**Champlain Hudson Power Express ("CHPE")
Environmental Management & Construction Plan
Notice of Major Change**

Project: Champlain Hudson Power Express

Notice Number: 084

Location (Milepost, Town/County): Certified Route MP 198.7 to 199.1, Town of Bethlehem, Albany County, New York

PERMIT DRAWING NO.
 DRAWING NO.
C-301A
 127

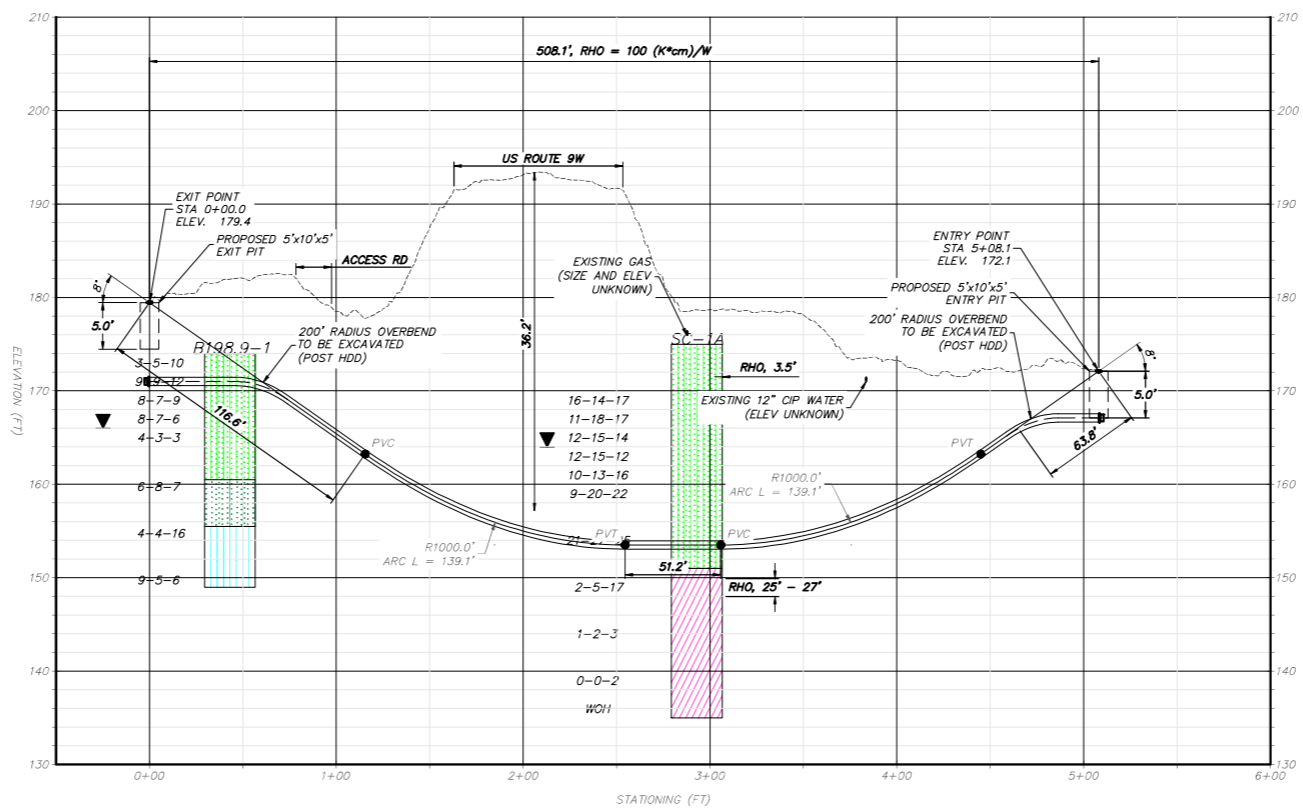
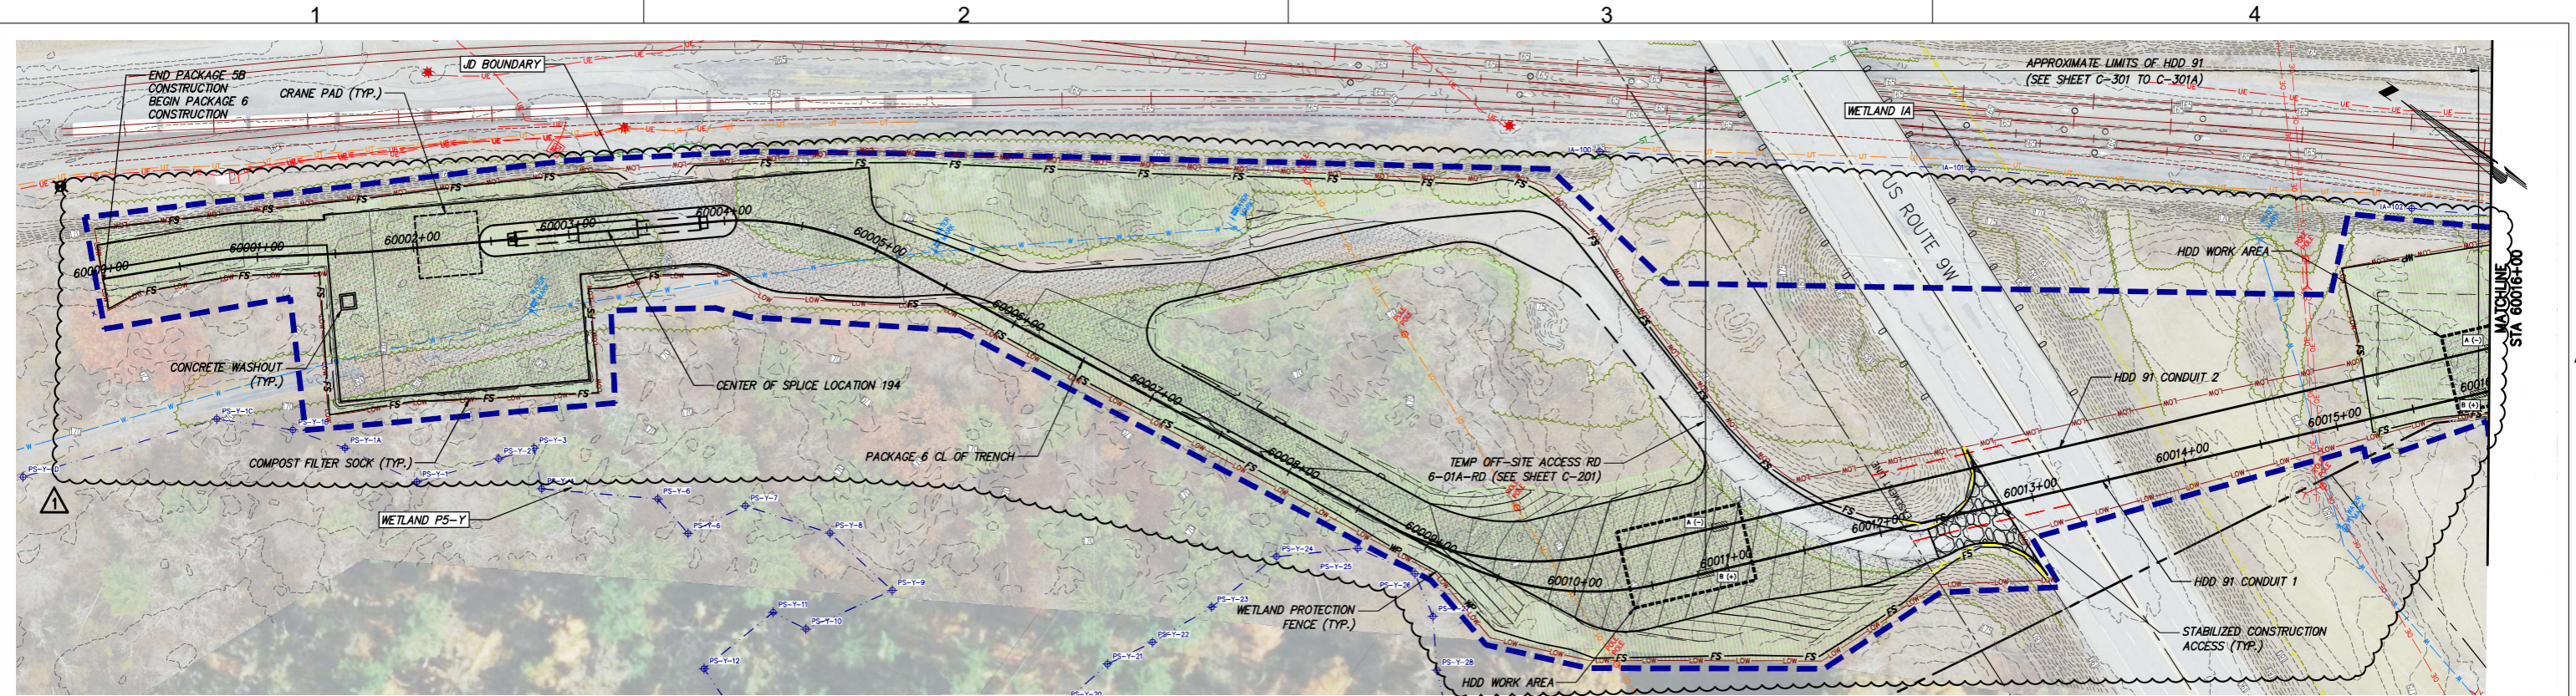
No.	DATE	SUBMITTAL / REVISION DESCRIPTION	DB	APP
1	02/13/2024	NDC-0054 HDD 91 REALIGNMENT FOR NEW RTE 9W BRIDGE	SA	TK
0	11/29/2023	ISSUED FOR CONSTRUCTION SUBMISSION	BV	TK

At Kiewit Engineering’s (Kiewit) request, HDD 91 was modified to accommodate a new bridge abutment on US Route 9W. The alignment was shifted approximately 60 feet to the west to allow for a minimum 100 foot offset between conduit 2 and the closest proposed point of the abutment.

PERMIT DRAWING NO.	N/A
DRAWING NO.	C-401

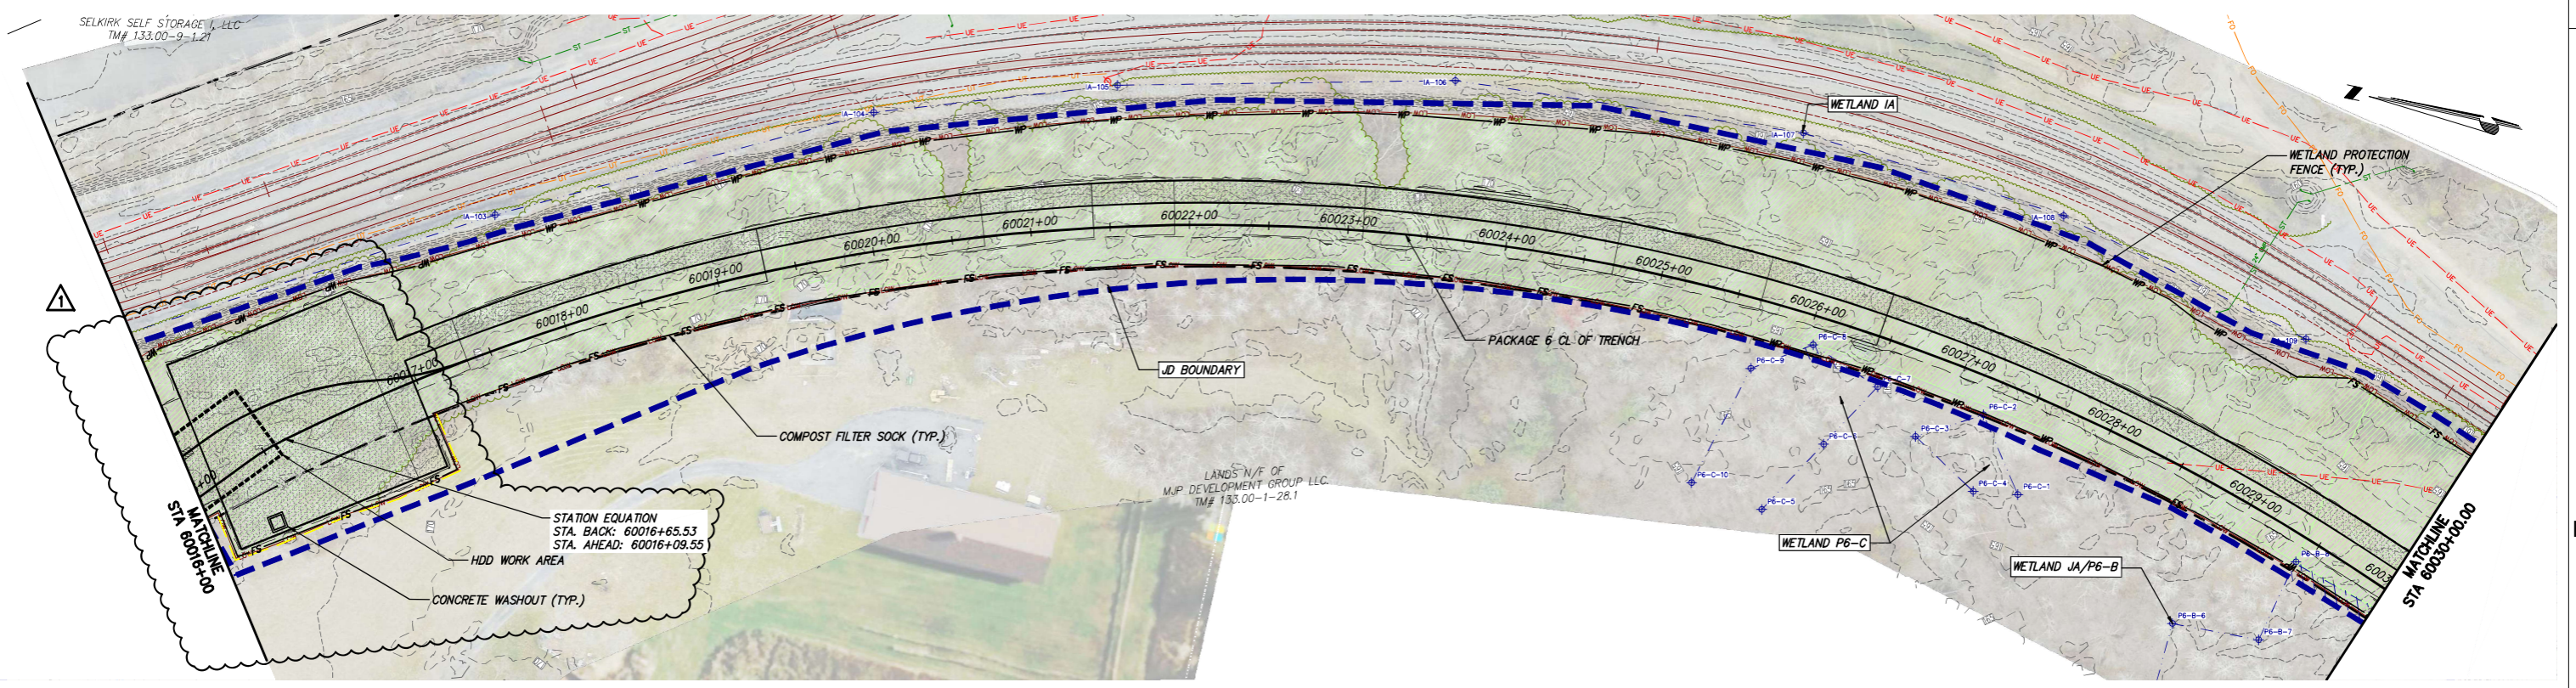
No.	DATE	SUBMITTAL / REVISION DESCRIPTION	DR	APP
1	02/13/2024	NDC-0054: HDD 91 REALIGNMENT FOR NEW RTE 9W BRIDGE	JR	BD
0	09/29/2023	ISSUED FOR CONSTRUCTION SUBMISSION	TH/MK	NH

Appendix E. Segment 10 Alignment Excursions

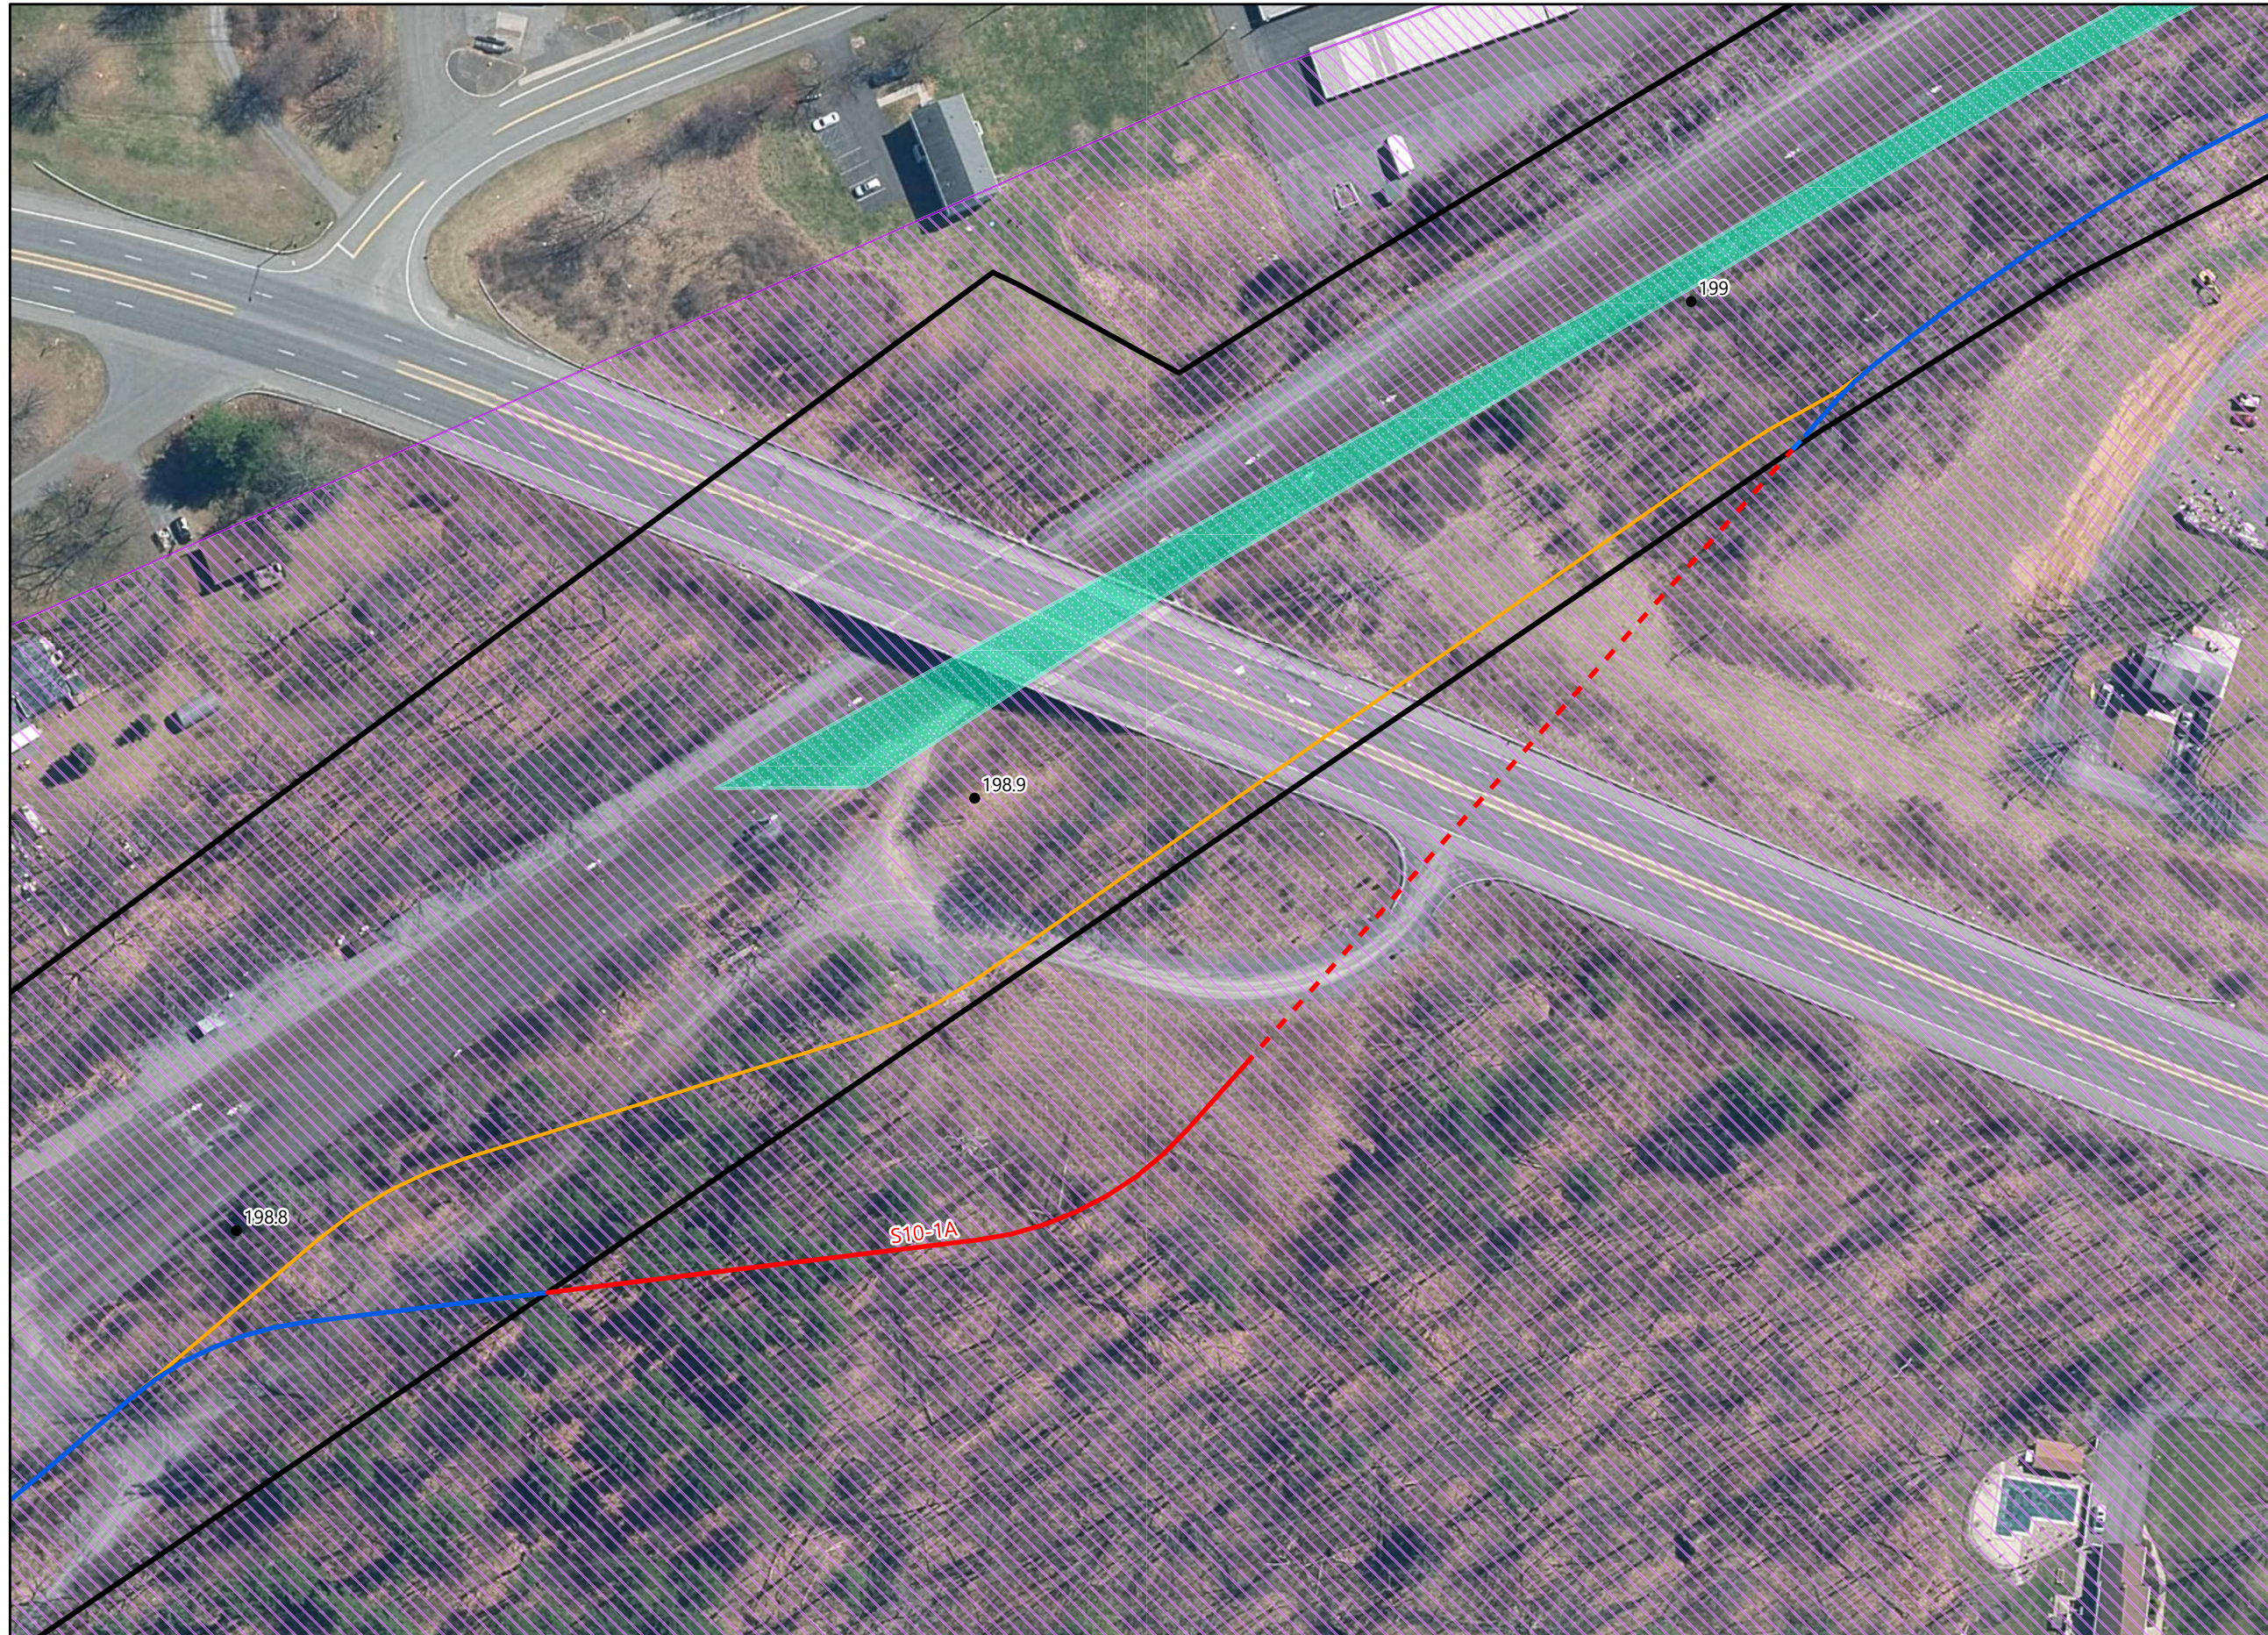
The Deviation Zone Excursion Table 1 of EM&CP "Appendix E Justification for Deviation Zone Excursions in Segment 10" is revised below:

Excursion S10-A is located within the Town of Bethlehem beginning about 670' NW of US Route 9W Crossing of CSX tracks (approximately STA 60004 to 60017 on Sheet C-101 and C-102 of the Plan and Profile Drawings [Appendix C of the EM&CP]).

NYSDOT provided plans for a future bridge at the US Route 9W Crossing over CSX Railroad tracks and required that the CHPE alignment maintain a minimum clearance of 100 feet to the nearest proposed structure (wingwall). Given the constraints at or near the CSX tracks in conjunction with the NYSDOT clearance requirements, this ADZ Excursion request is grounded in engineering reasons and is the minimum necessary to feasibly achieve installation.

The anticipated ADZ exceedance constitutes a major change as it's 141 feet perpendicular to the ACZ at its furthest point; environmental impacts will be minimized, and the overall character of the Facility will not be changed. A detailed impact review and summary of environmental considerations are provided below. 525' HDD and 402' trench
